From: gshaff@gmail.com
Sent: Tuesday, March 11, 2025 6:45 PM
To: Planning Commission - Public Testimony
Subject: HEARINGS PLANNING ACTION: PA-T2-2024-00053 - Variance

RE: PLANNING ACTION: PA-T2-2024-00053 – 231 Granite Avenue

To: Planning Commissioners
From: Amy Gunter, Rogue Planning & Development Services, LLC
Date: March 17, 2025
Re: PA-T2-2024-00053

DATE: March 18, 2025
TO: Planning Commission
FROM: Brandon Goldman, Community Development Director
RE: 231 Granite Street

DRAWN: TS CHECKED: CD
DATE: 03/12/25
PROJECT: ROGERS_24
SHEET: **AS1.1**

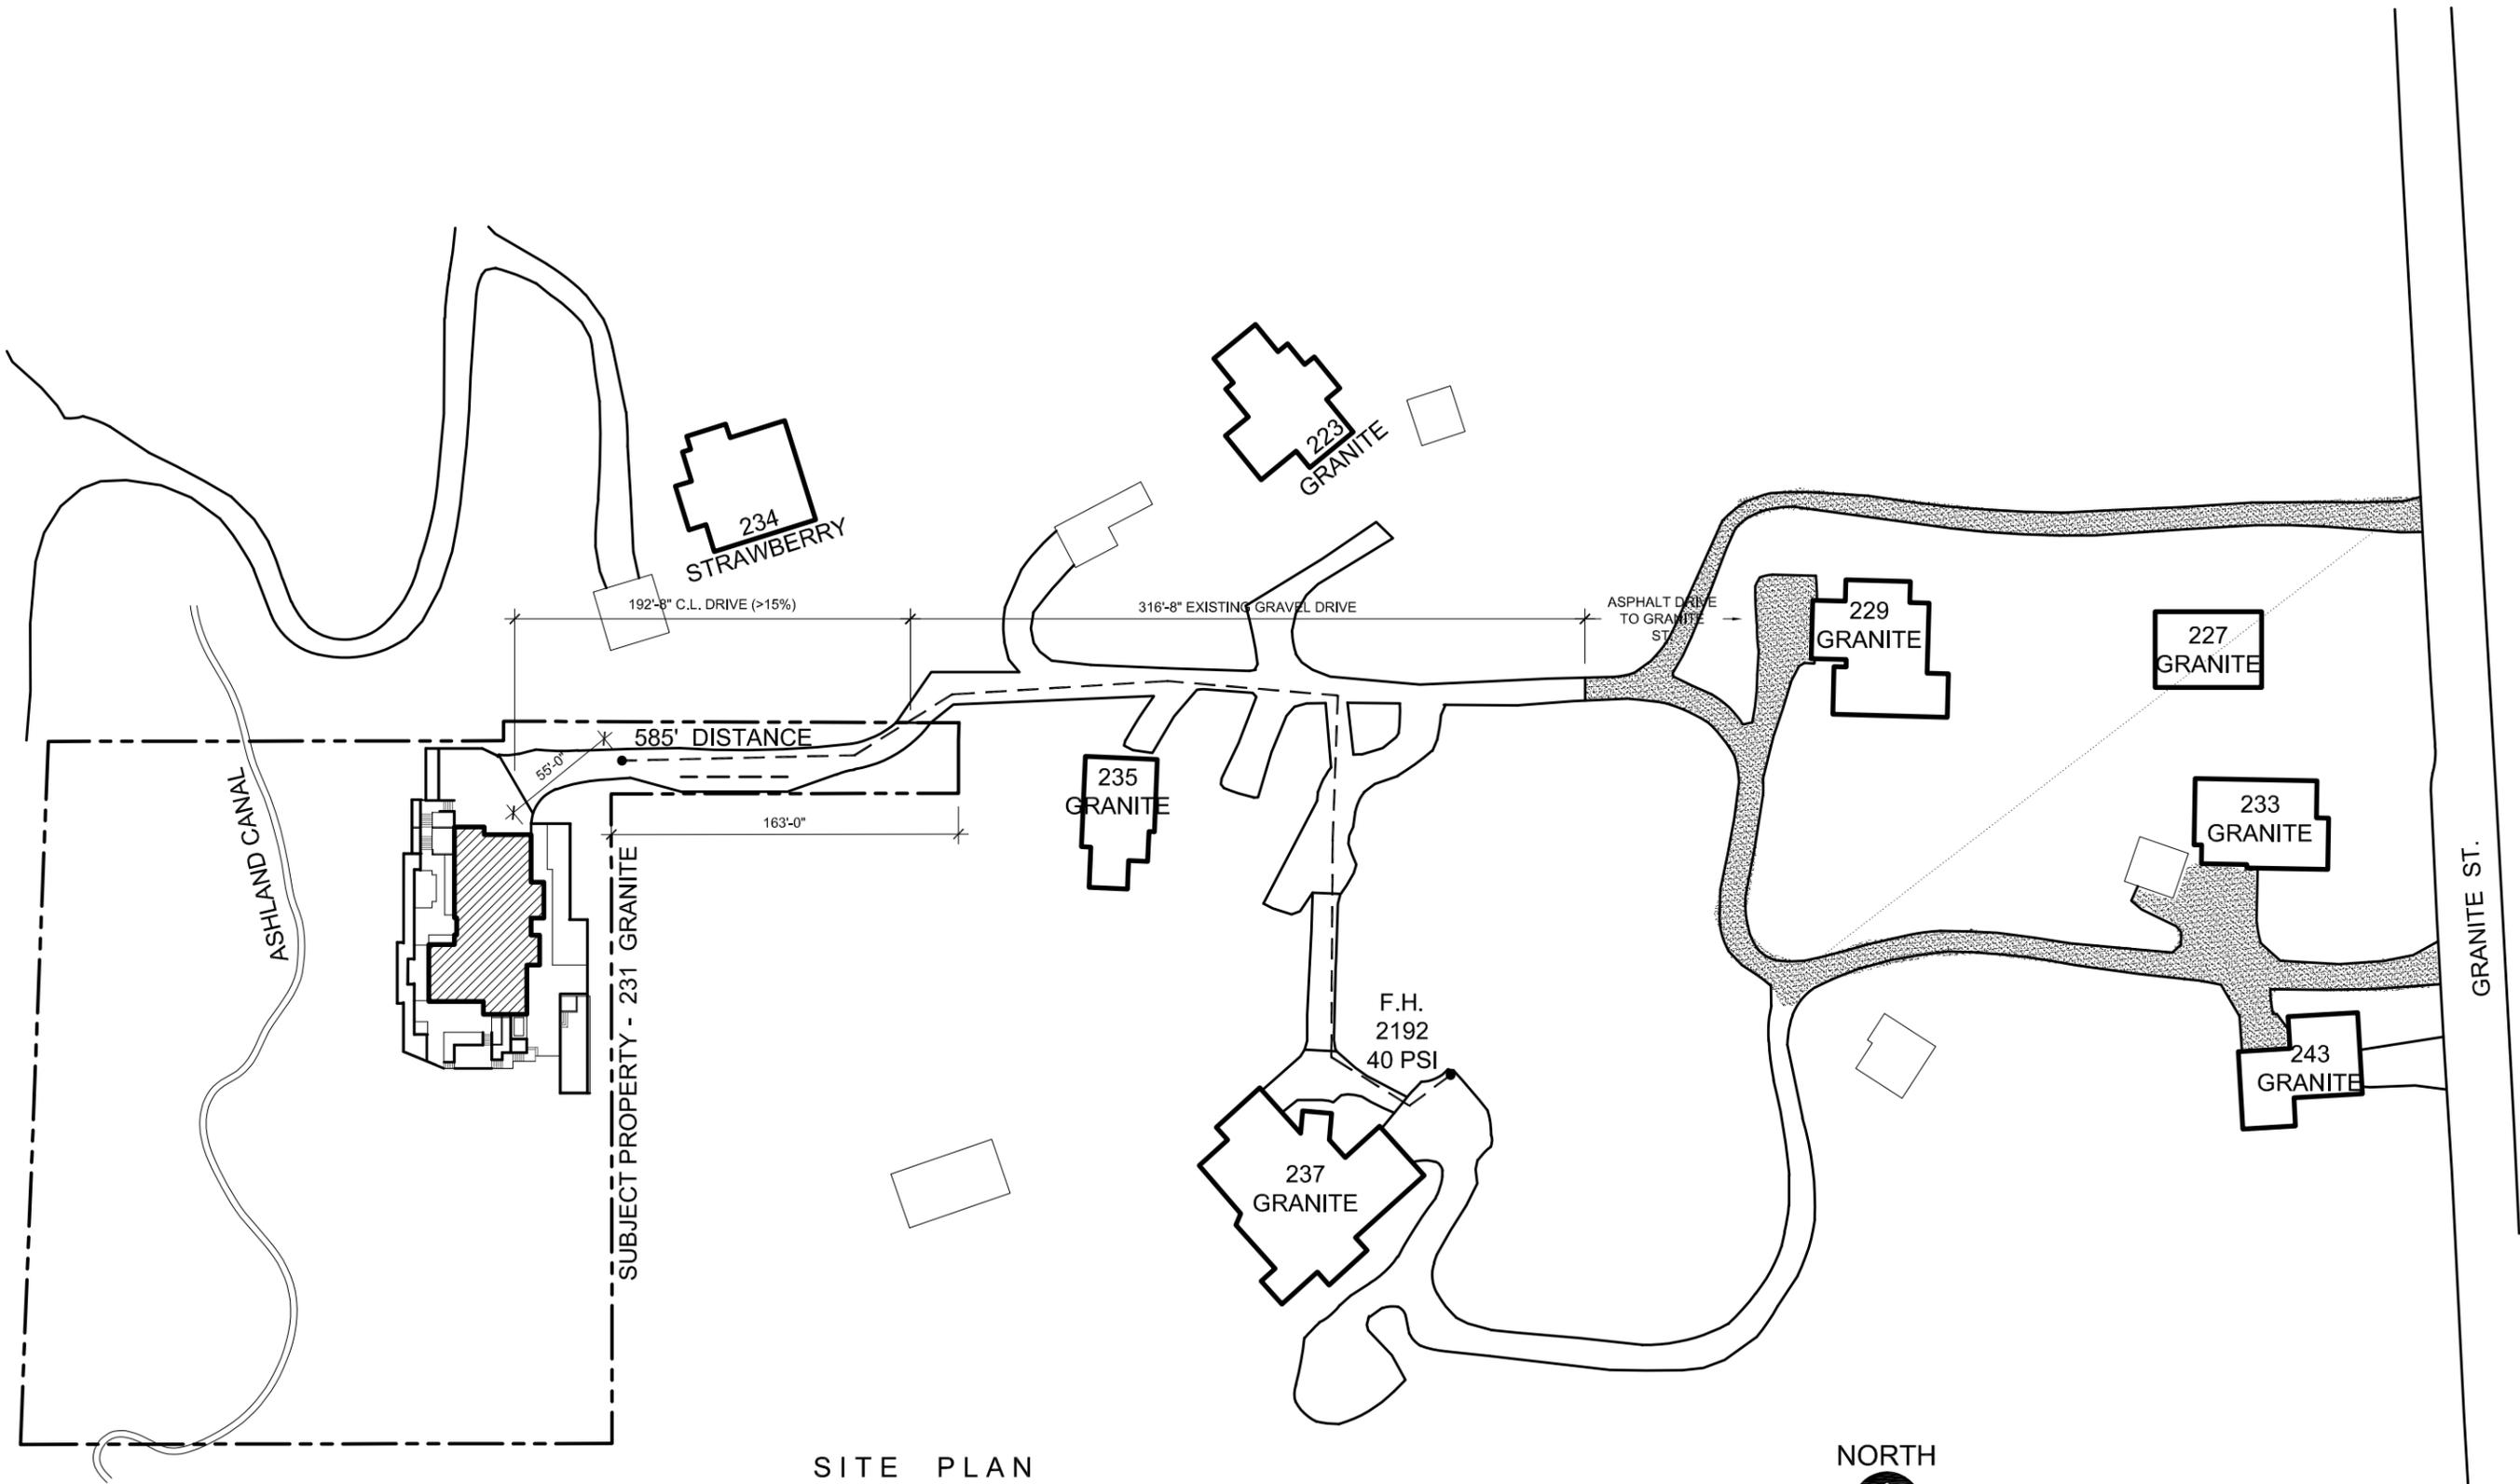
Commissioner Herron asked pointed questions about the length of the driveway and public comments from citizens indicated that the supplied length of the driveway may be inaccurate. The 197 feet in the application is measured linearly on the map, not following the course of the driveway. In fact, the measurement courses outside the boundaries of the tax lot. Best practice for surveyors includes measuring the length of the driveway along the centerline of the driveway. If the driveway is curved, distances are usually measured along the actual travel path, rather than a straight-line approximation. For instance, a driveway that travels north for 200 feet from point A to point B and then turns ninety degrees and travels west for 200 feet to point C is 400 feet long. No reasonable person would describe the length of the driveway as the distance directly from point A to point C (283 feet).

During questioning and response during the March 11 public hearing, commissioners noted there is no turnaround and asked if the plan was for emergency vehicles to back out of the driveway after accessing a structure in the proposed building envelope. The applicant indicated that yes, backing the vehicles up was the plan. The applicant said that there is a pseudo-hammerhead turnaround located below the applicant's property on the shared easement driveway from Granite Street, implying that this fulfills turnaround requirements. This pseudo-hammerhead turnaround is another 150-160 feet from easternmost end of the subject flag lot. This is a total of about 360-370 feet from the proposed single-family dwelling. This far exceeds the intention of **ALUO 18.5.3.060 J.**, which clearly aims to have a turnaround within 150 feet of a structure, or within 250 feet in extenuating circumstances with appropriate approval. With the additional 100 feet to reach the far side of the house, the distance from a turnaround increases to 460-470 feet. This is a significant distance, including a steep slope, that far

The proposed driveway length on the subject property is 183 feet and 223 feet to the edge of the existing gravel-surfaced driveway. This existing and proposed driveway exceeds 18 percent and exceeds 200 feet in length. The requested variance for the required access to the property is not only for the grade but the maximum length of the allowed grade. A graphic of the entire driveway has been provided on attached Sheet AS1.1., AS1.2., and on the Civil Sheet (C1).
